ERTMS/ETCS & ERTMS/ATO

**Exceptions for on-board reduced envelopes of ETCS
system versions**

REF : SUBSET-153

ISSUE : 0.1.0

Figure 31: Brake Build Up Time Model

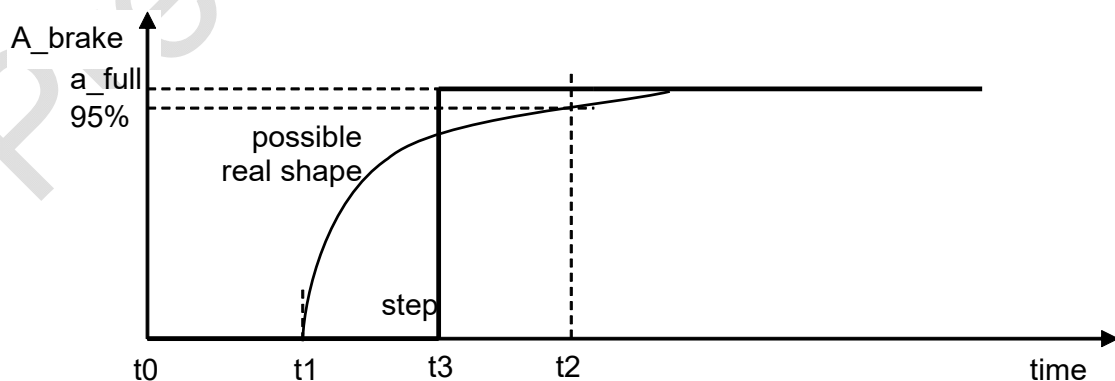
5.2.1.25 The clause 3.13.2.2.3.2.2 and the Figure 31 shall be replaced with: "The model for the brake build up time shall be given as a step function as explained in Figure 31."
